**FLOODPLAIN MANAGEMENT COMMITTEE
TO BE HELD IN THE COUNCIL CHAMBERS ON
THURSDAY, 11 JUNE 2026 AT 2:00 PM**

TITLE **Lake Wyangan Flood Study - Response to Submissions**

Lake Wyangan Flood Study Review and Update – Response to Submissions

Source: Figure 1-1 of Draft Flood Study

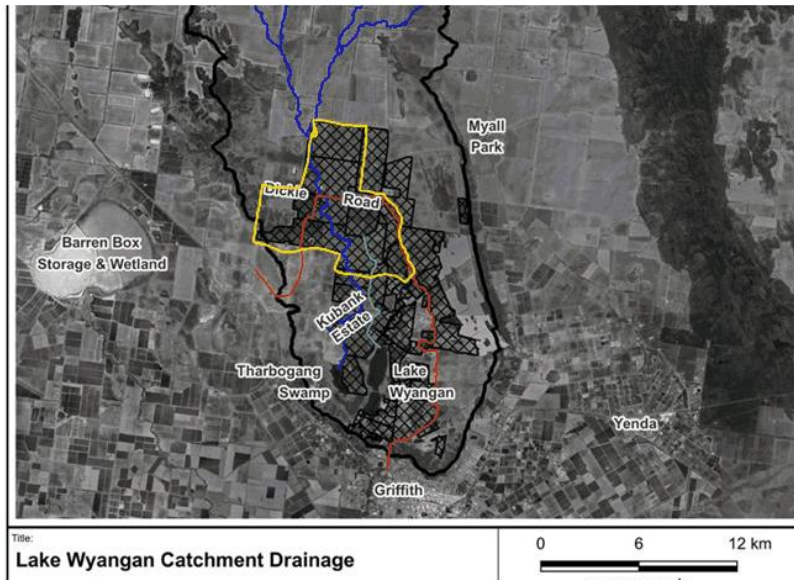
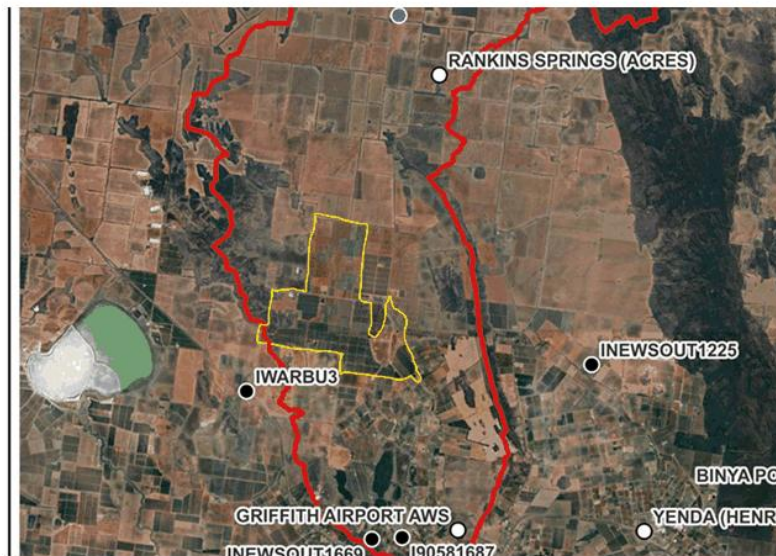
Further inconsistency is apparent when comparing Figure 1-1 (page 30), which depicts the Lake View Drain extending north from Lake Wyangan, without including the East–West Drain, with subsequent figures and narrative that appear to treat the systems collectively.

Approximate location and size of our Client's Property (outlined in yellow below)

Options to improve the clarity of the satellite imagery figures will be considered, such as including some of the key features shown in Figure 1-1. However, this may obscure some of the important detail visible in the figures, but it is agreed that some additional spatial context of infrastructure would be helpful in interpretation. The extent of water in the satellite imagery can be more difficult to discern within the broader orchard extents than the cleared earth sections. Also, the dates of the satellite imagery do not capture the maximum extent of flooding experienced during the events.

Source: Figure A-26 of Draft Flood Study

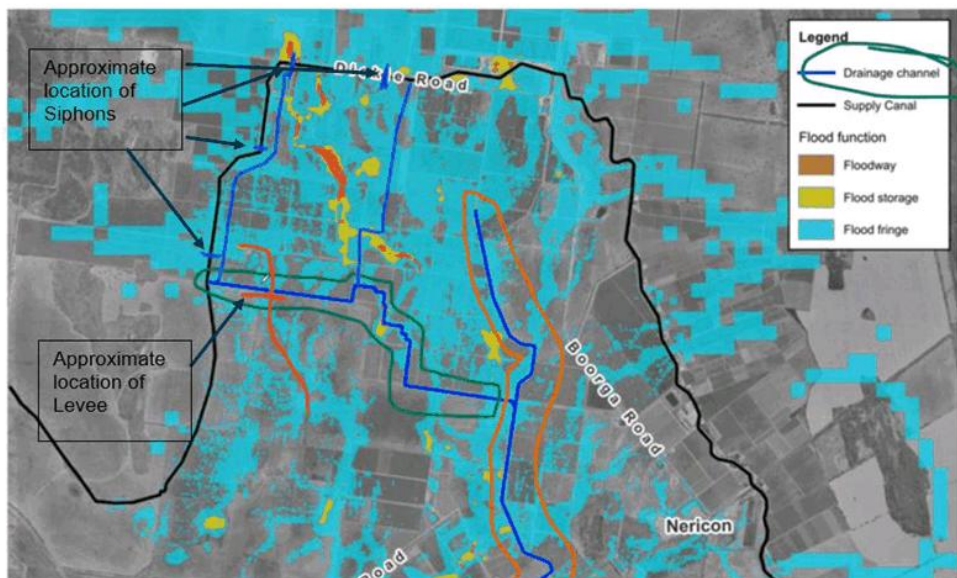
- Figure A-18 (page 113) illustrates flows being conveyed eastward along the East–West Drain, with localised overtopping where capacity is exceeded, resulting in redistribution of water to the south;
- Areas of reduced flood affectation immediately south of the East–West Drain suggest that overland flows are being intercepted and redirected along the channel; and
- localised overtopping is observed where flow capacity is exceeded, resulting in redistribution of water to the south.

Client's Private East-West Drainage Infrastructure (circled in green below)

Figure 1-1 Shows the extent of planned breaching by Council

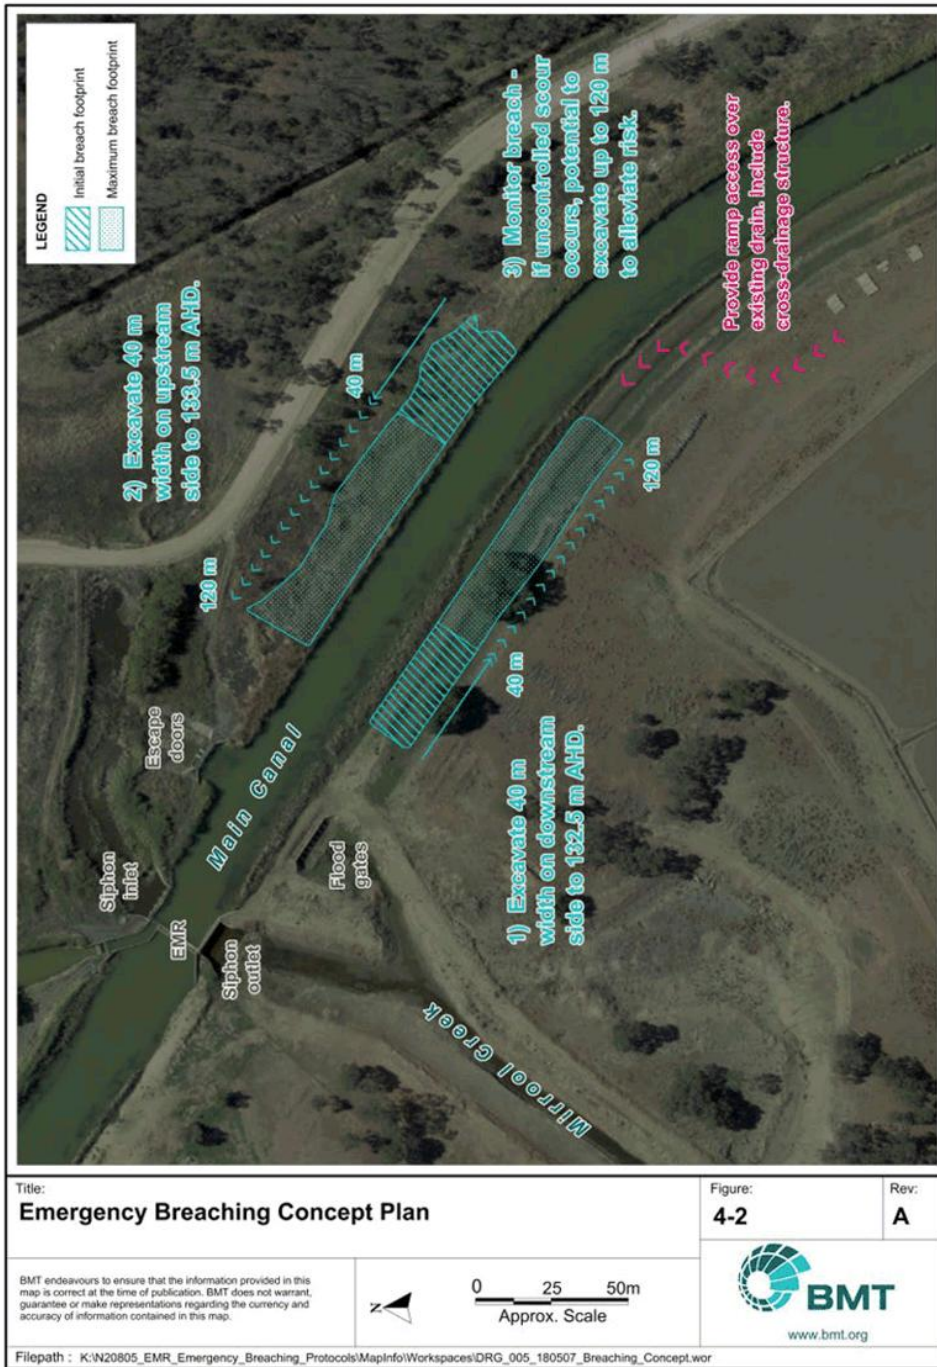
“That Council commission a Geo-Technical soil survey of the entire proposed site of Council’s endorsed Emergency Breaching Protocol (EBP) “

The history of building the Main Canal by horse and drag scoop we are all familiar with. The problem arises when the Main Canal crosses the centuries old Mirrool Creek bed made up of alluvial silts and sands. Not the stable material an engineer worth his salt would design a water overflow across and expect it to withstand the erosive forces of thousands of megalitres of water rushing over it. Therefore, it is imperative Council conduct a Geo - Technical soil survey of the entire Main Canal banks (120 metres in length) where Council’s Emergency Breaching Protocol will be enacted. If the Geo - Technical soil survey supports a EBP event well & good. If on the other hand the Geo- Technical soil Survey fails to support an EBP event Council is better informed as to the possible impacts downstream of unplanned uncontrollable breach may cause and a potential disaster is averted. Consultants BMT stated in their EBP report “that a flood event greater than 100M³per sec (8640 ML per day) would result in uncontrollable breaching.”

Figure 3-3

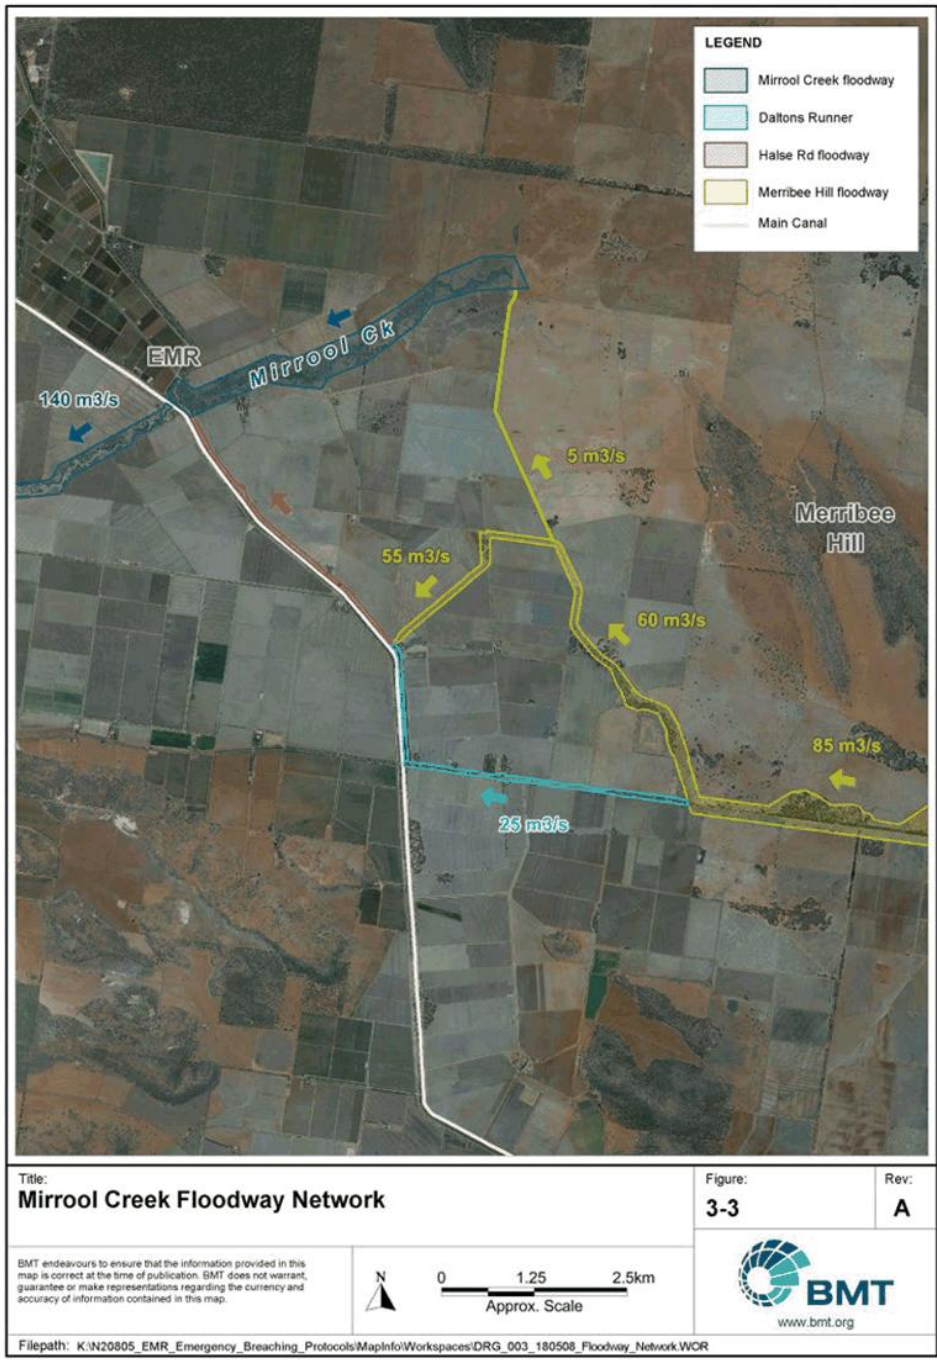
RECOMMENDED ON THE MOTION OF Paul Rossetto & John Kerrigan that the Floodplain Management Committee recommend to Council the completion of the Reinstatement of EMR floodgates option presented by consultants BMT WBM Griffith Main Drain J and Mirrool Creek Floodplain Management Study Plan August 2015. C.2 EMR Flood Escape Upgrade. C.2.1 Description of Works.

- Construction of new flood relief structures at the East Mirrool Regulator as a replacement of the existing structure. The existing five bay and eight bay flood check in the northern and southern bank of the Main Canal is proposed to be replaced with a 9 bay 2.4 x 1.8 m gated structure (or similar) on each bank.
- Scour protection works at the structure inlets and outlets are provided to protect the receiving channel and downstream floodplain from excessive erosion.
- Channel modification works are required both upstream and downstream of the structure to provide appropriate transition of flow to the existing channel /floodplain of Mirrool Creek.
- Raising of and strengthening of the righthand bank of the Northern Branch Canal

The 2012 Flood event saw 140m³/sec cross the Main Canal in several breaches including the under-canal siphon (3700ML per day)
